TCEP Project No.: 097-039-15
LPS Bid No.: 8365

ADDENDUM NO. 2

LPS Humann Elementary Renovation
6720 Rockwood Ln.
Lincoln, NE 68516
TCEP No.: 097-039-15
February 5, 2016

FIRST FLOOR DEMO PLAN - AREA 'C'
SCALE: 1/8" = 1'-0"

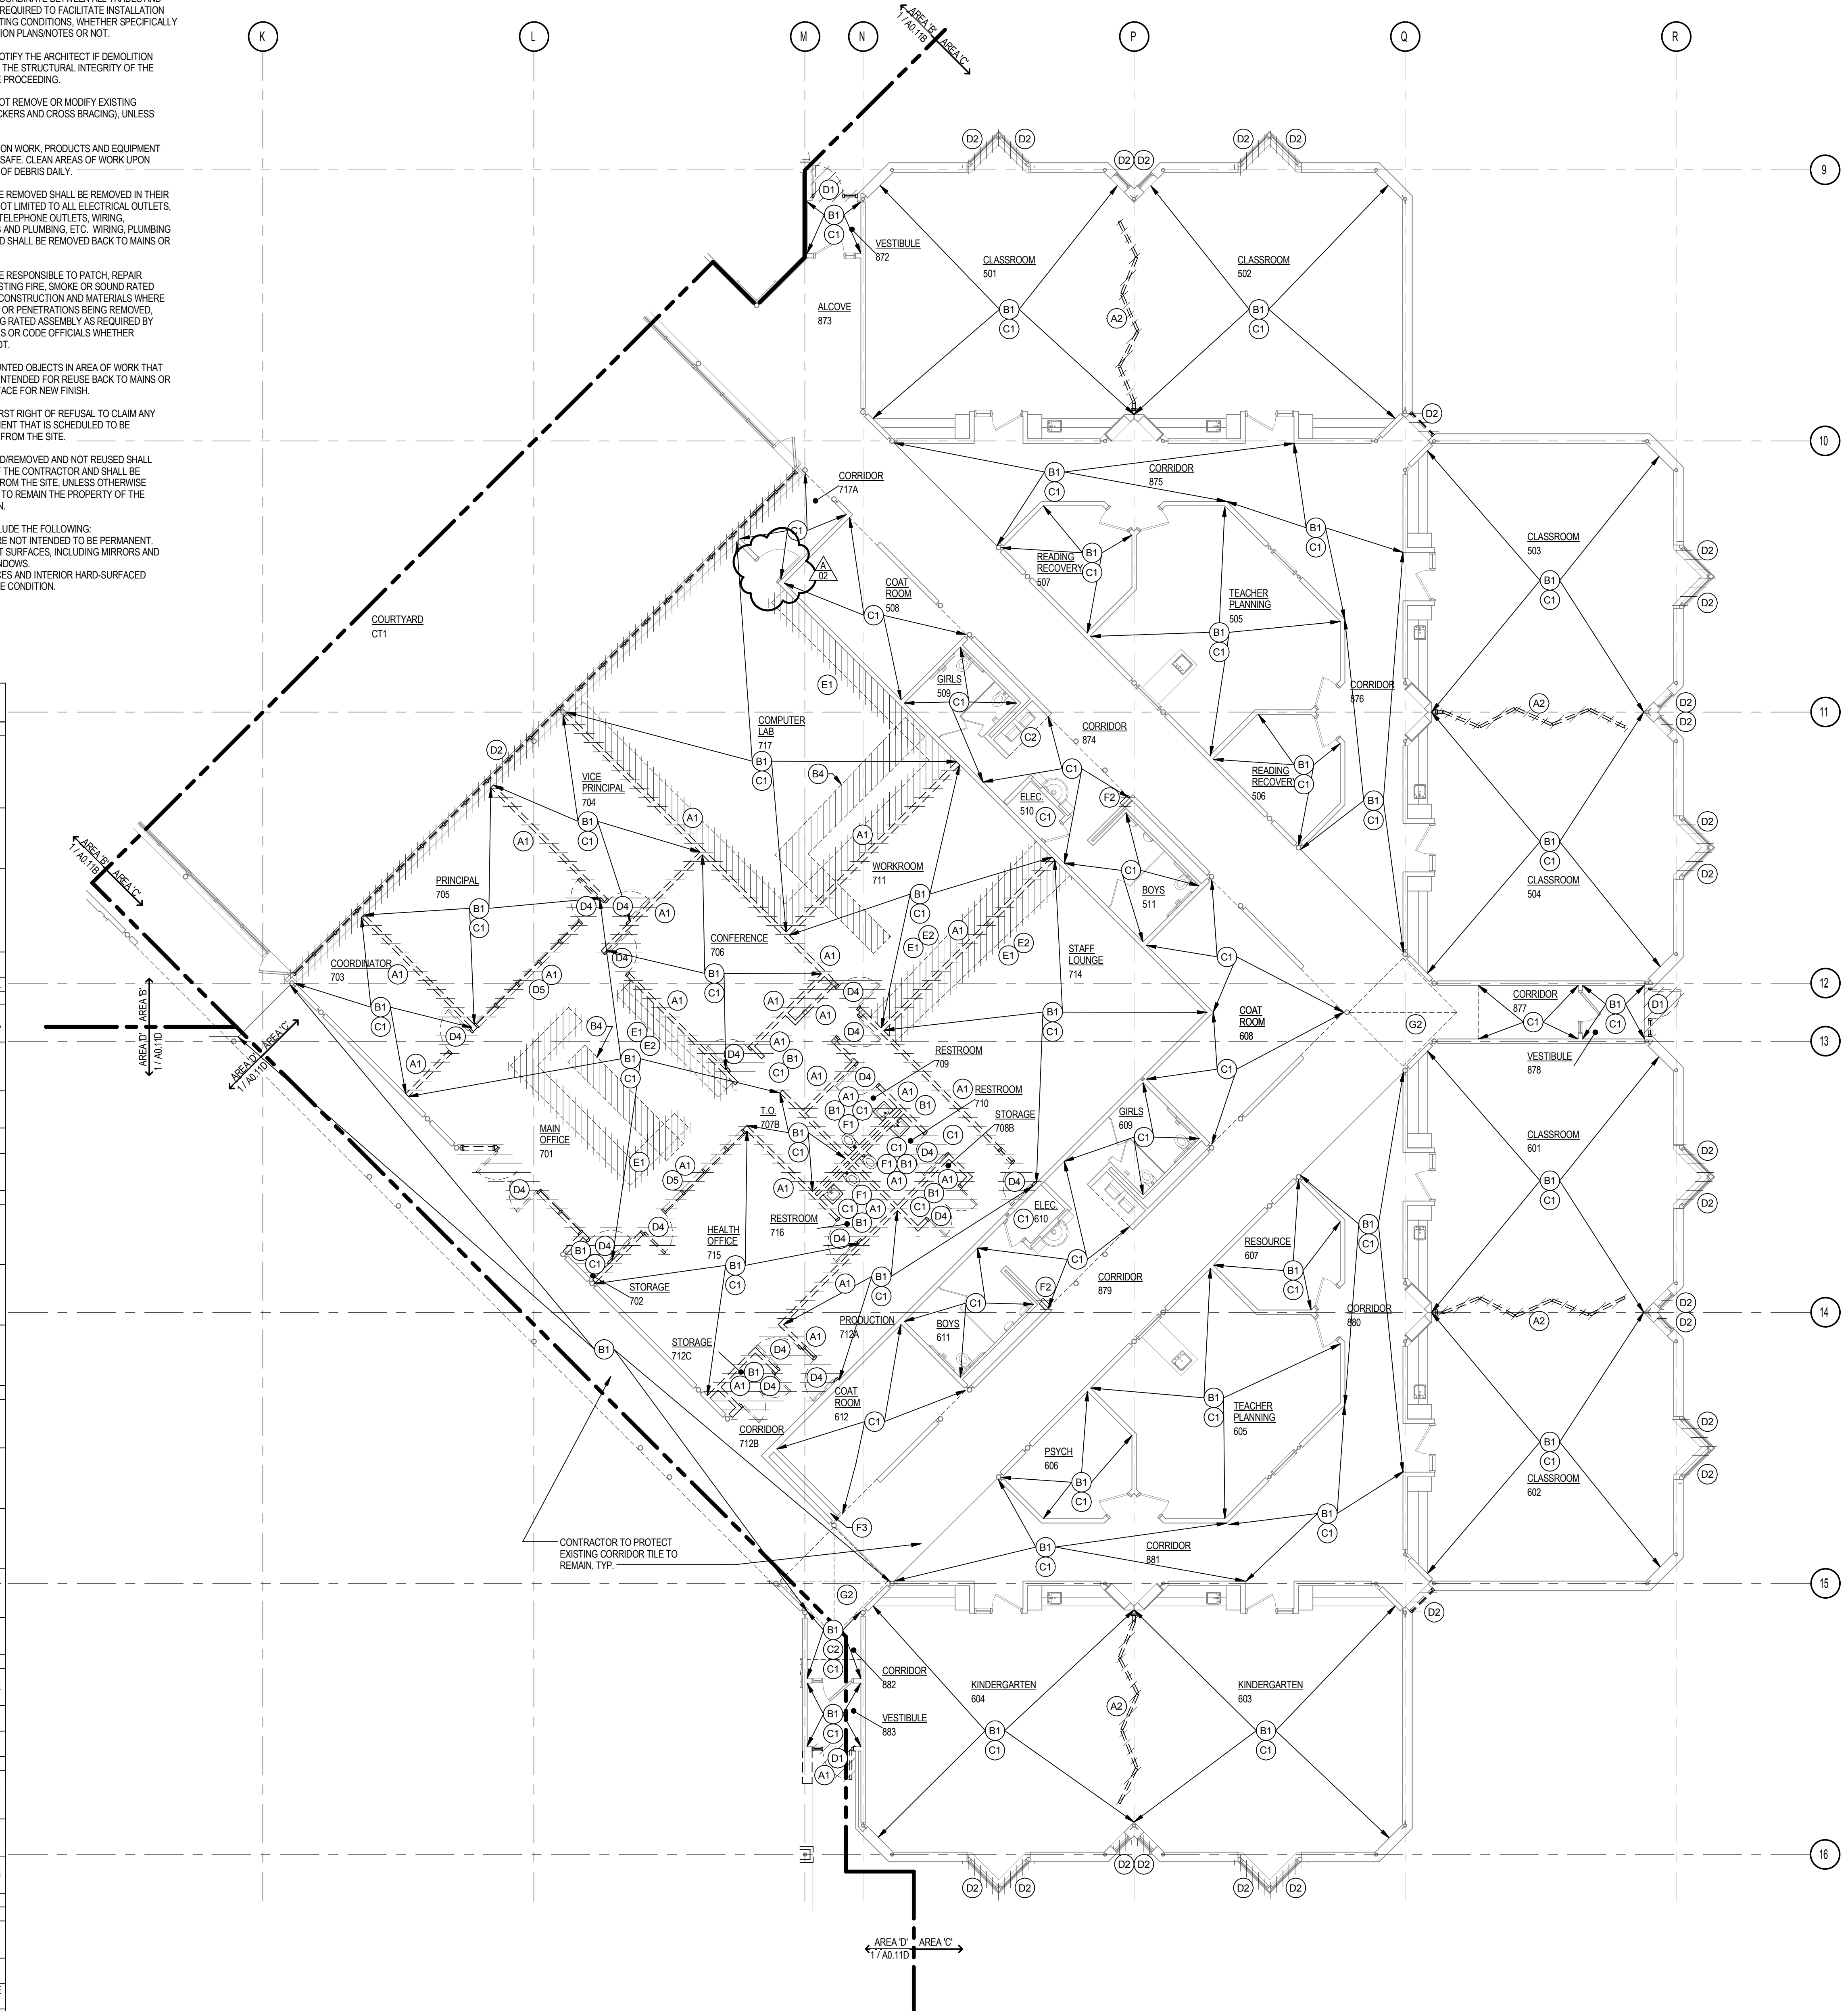
Do not remove door at new storage room adjacent to new Art 157as identified on the attached revised sheet.

12 PLAN DETAIL
SCALE: 1 1/2" = 1'-0"

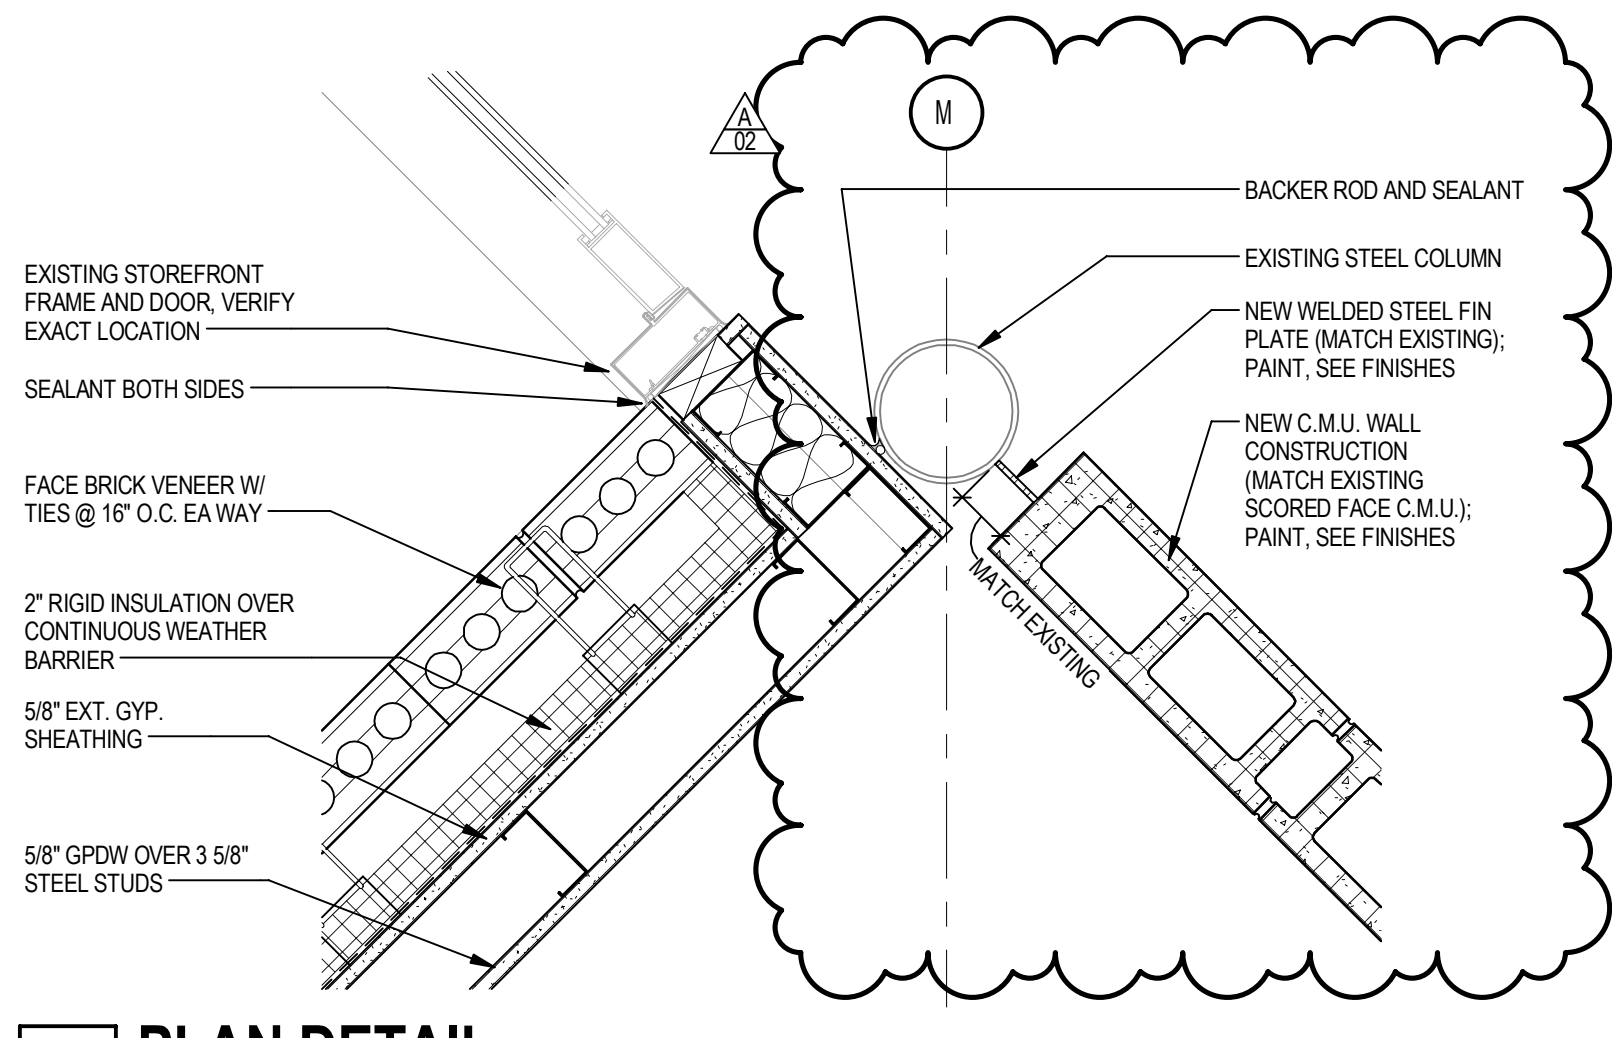
Modify plan detail 12 as identified on the attached revised sheet.
